AGENDA
City of Gig Harbor Design Review Board
Virtual Meeting of February 11, 2021

**COMMUNITY DEVELOPMENT DEPARTMENT
PLANNING DIVISION
STAFF REPORT**

RE: Skansie Mini Storage (PL-SPR-19-0010, PL-CUP-19-0002, PL-SEPA-19-0014, PL-DR-19-0088)
Public Meeting Date: February 11, 2021

**PLANNING DIVISION
DRB PRE-APPLICATION STAFF MEMO**

P:\20000\20693\preliminary\20693 CWA2.1 ELEVATIONS.dwg 11/13/2019 3:13 PM DSANTOS

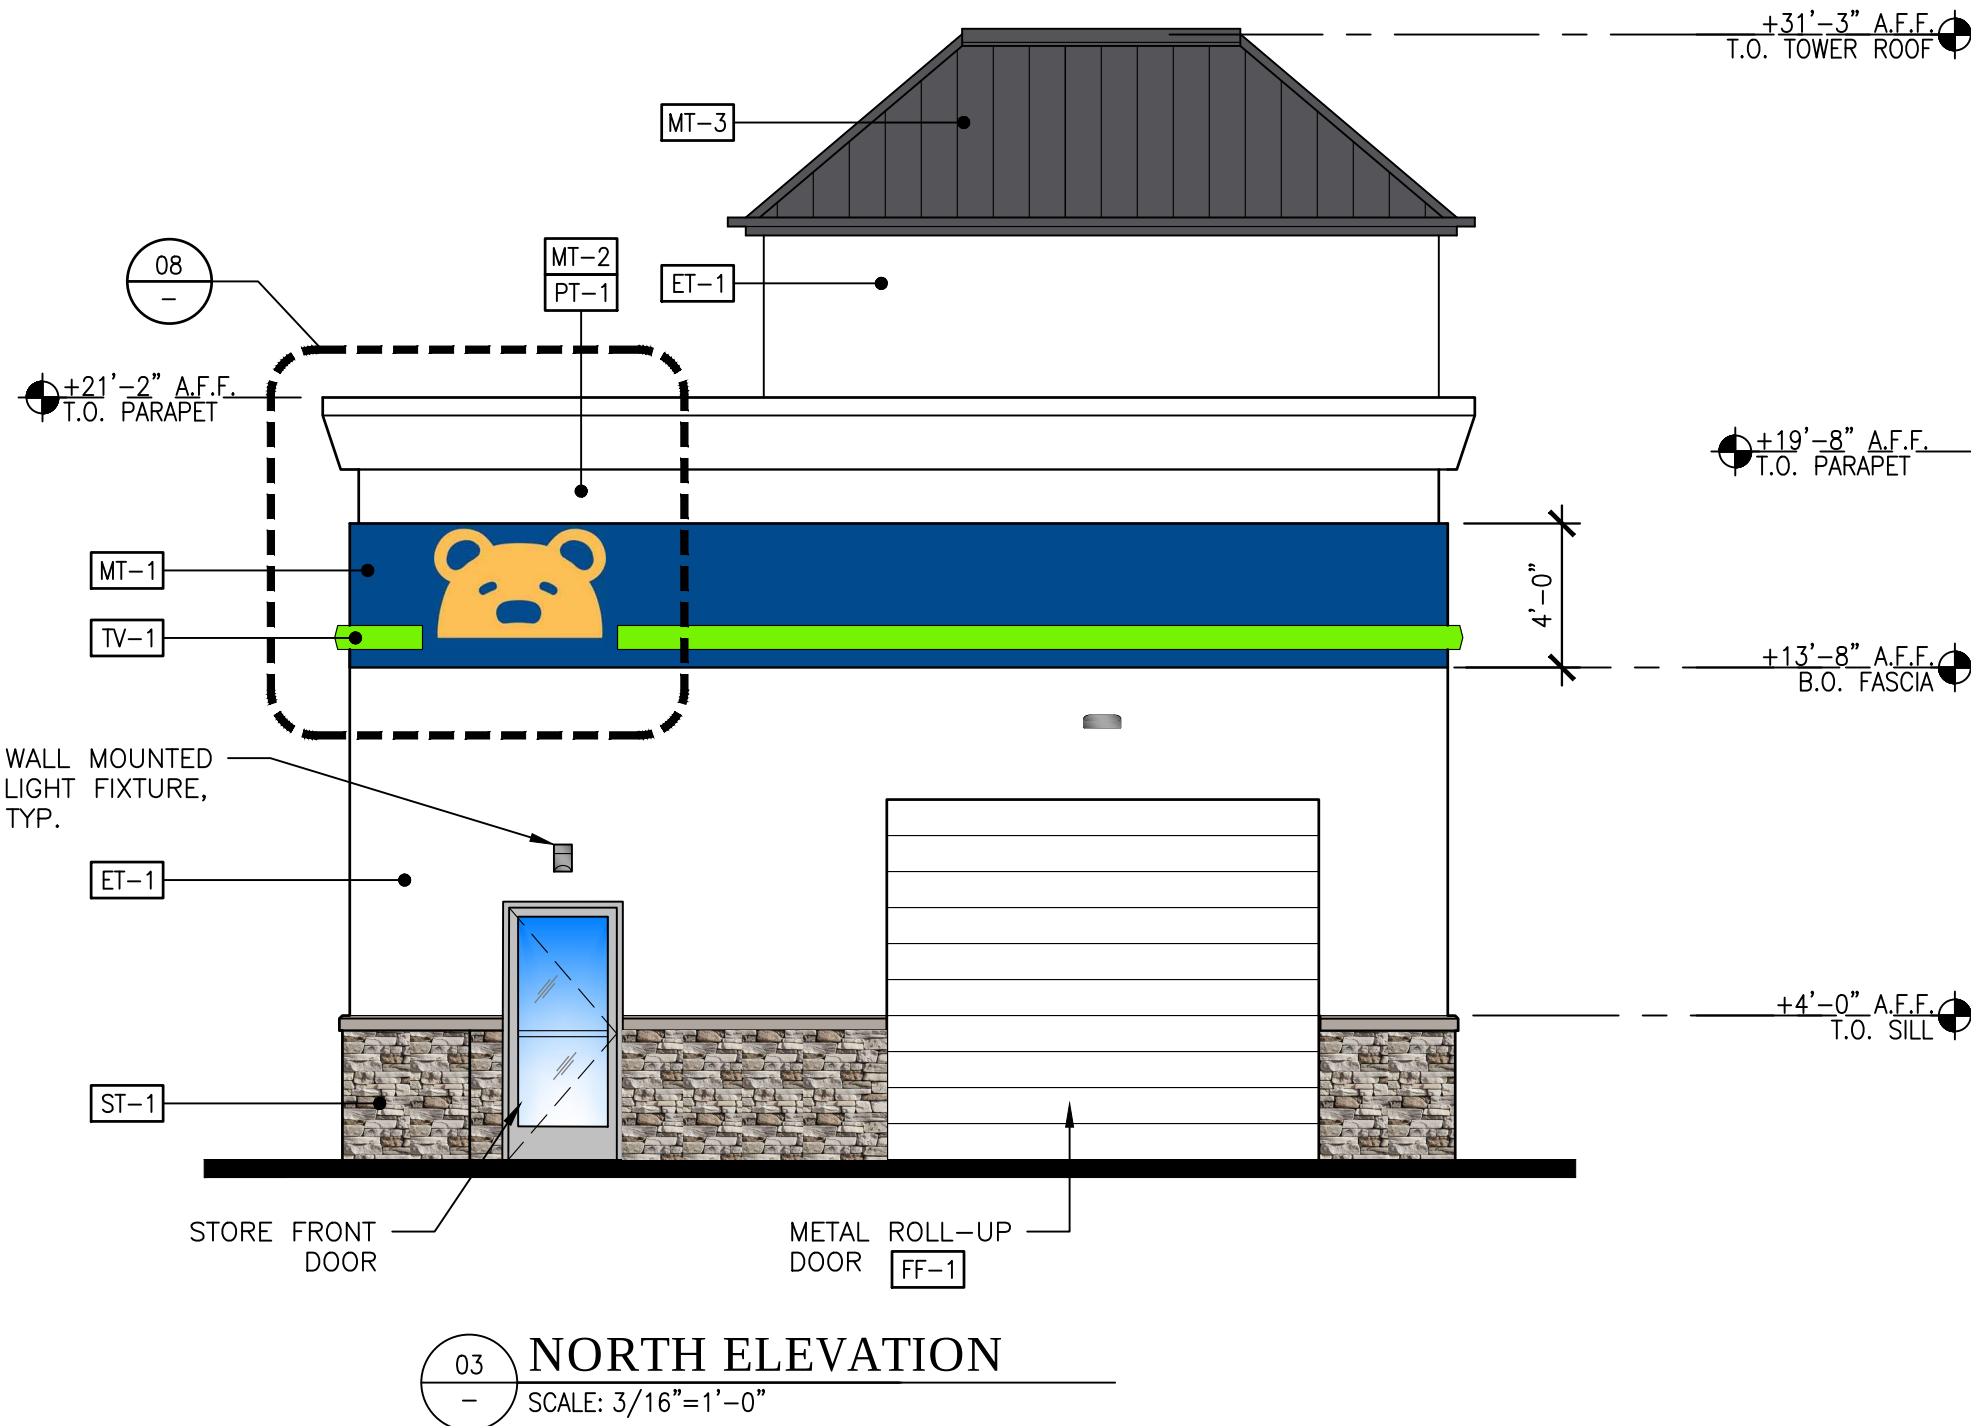
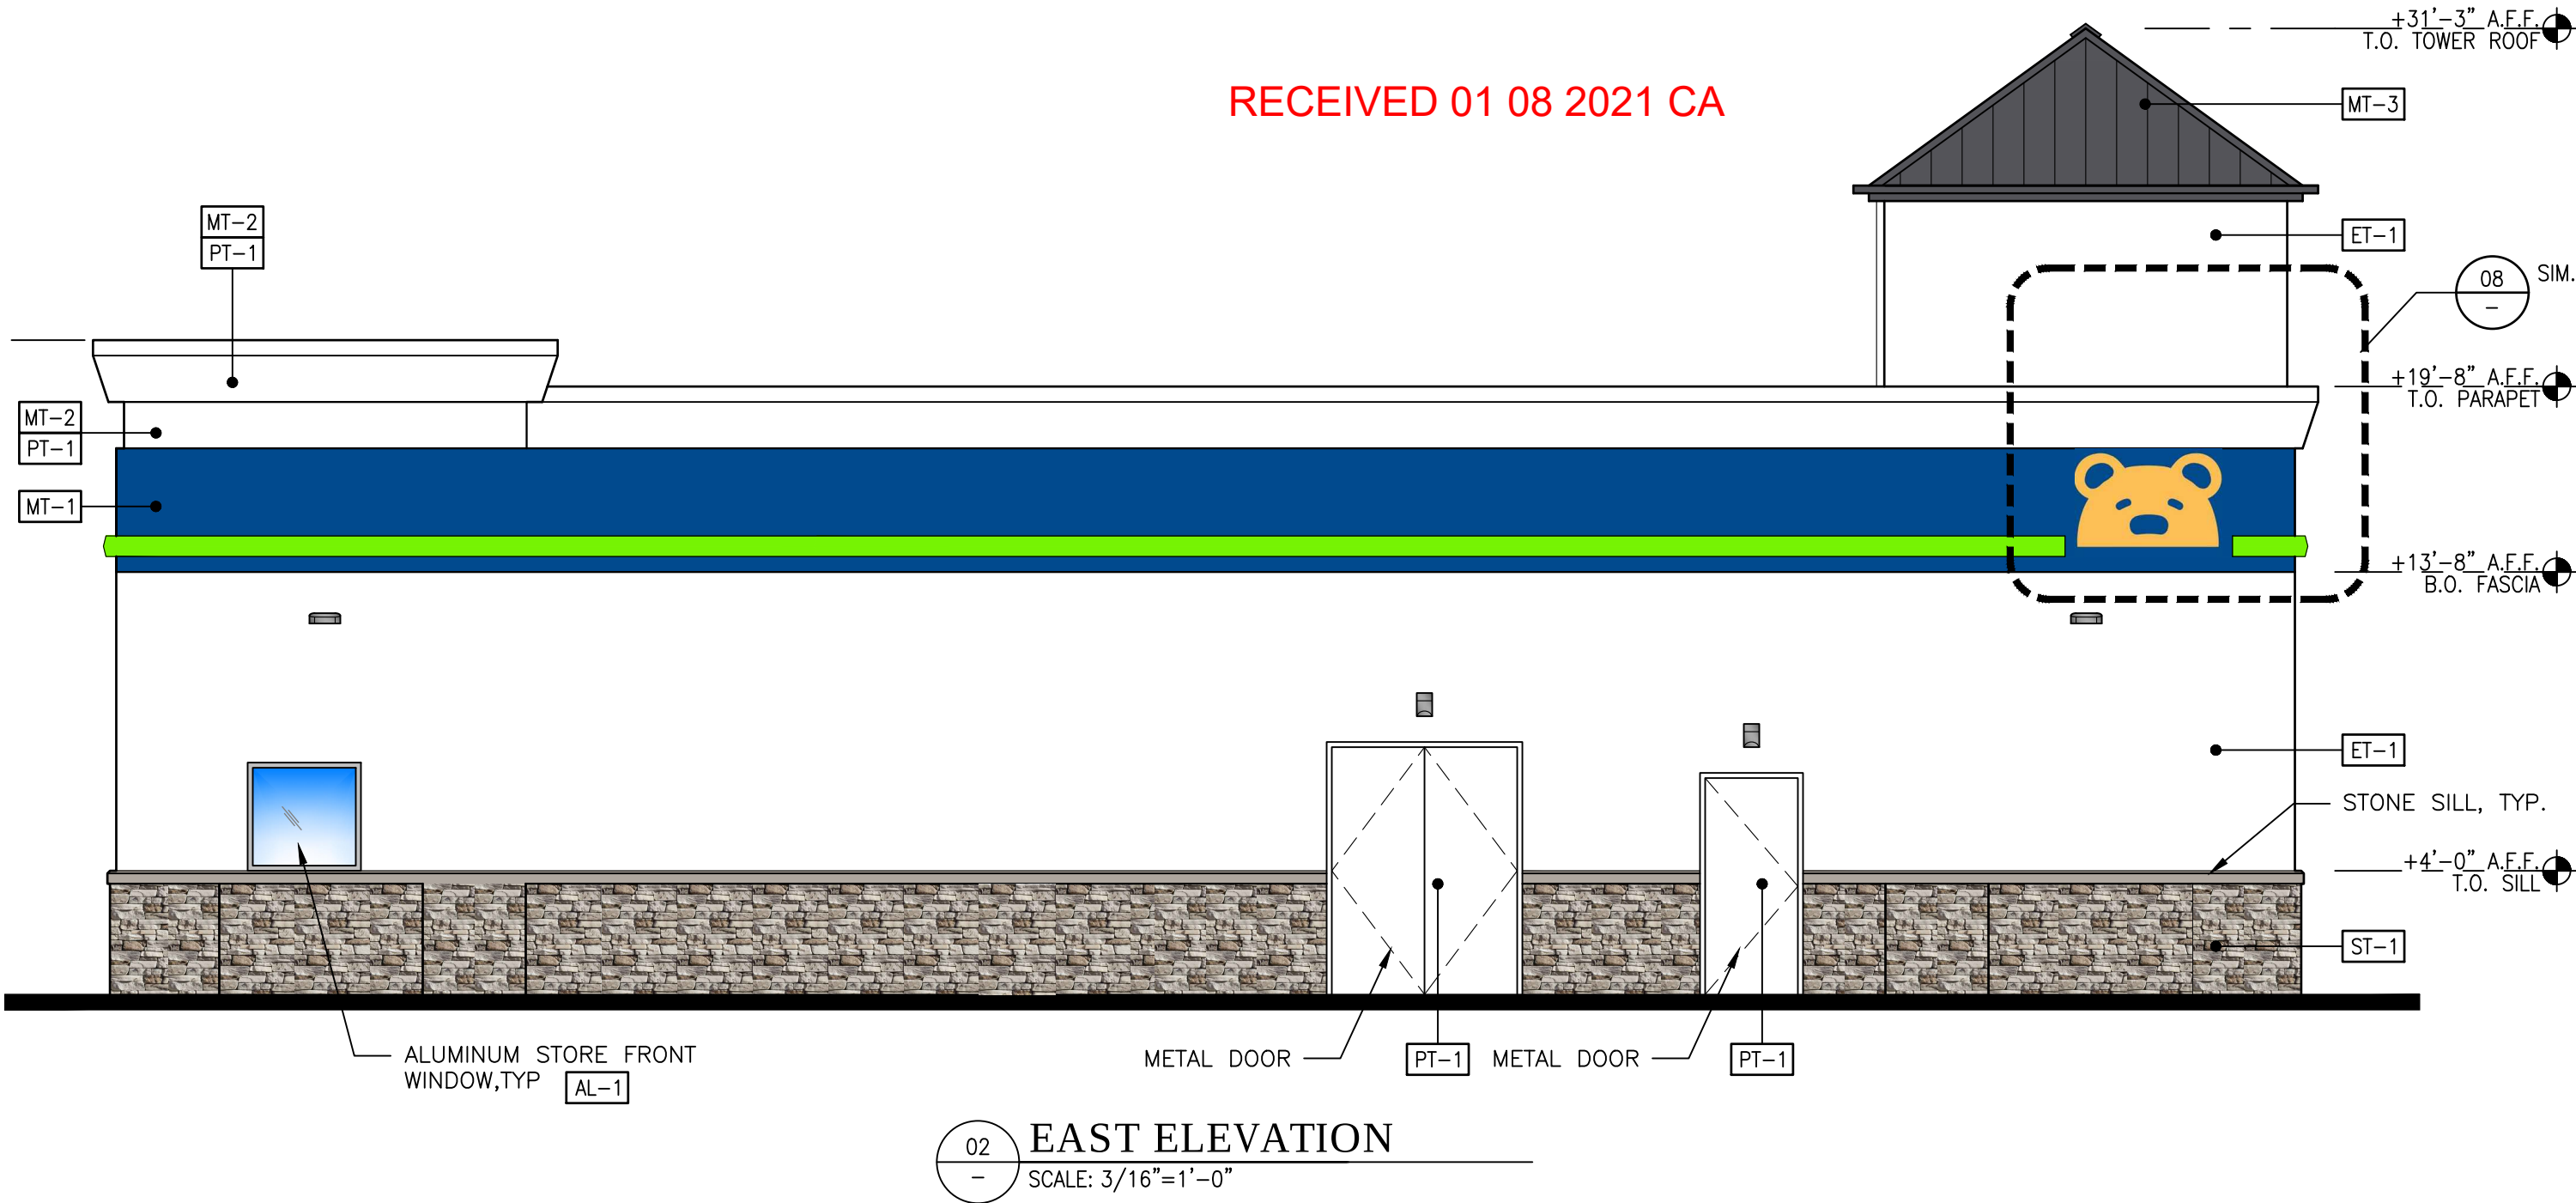
The proposed structure is 110 feet in length and 31 feet tall at its highest point with the majority of the wall plane for the proposed tunnel wash measuring approximately 20 feet in height. The length of the proposed structure exceeds the required limit of two and one-half times the height of the wall plane and no horizontal shift is proposed.

According to the applicant’s narrative, the proposed structure will include a “tower element” on the west elevation oriented to 32nd Avenue that will provide “articulation to the roofline.” However, the elevations provided by the applicant do appear to be consistent with the requirement of a vertical shift described in GHMC 17.99.380.B. The fascia appears to run in excess of 80 feet.

PRELIMINARY SITE PLAN
BROWN BEAR CAR WASH
5115 OLYMPIC DR
GIG HARBOR, WASHINGTON

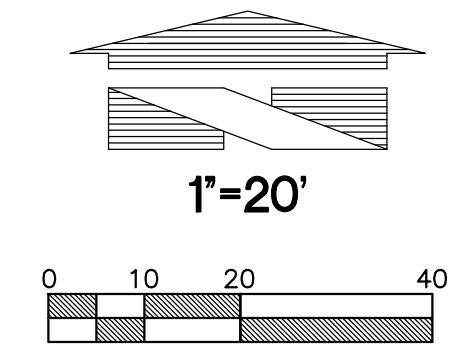
According to site plan, 50 percent of the proposed car wash is not shown on the front setback line.

While GHMC 17.99.300.B may result in the removal of the vegetated island containing 19 significant trees, the site plan and photographs
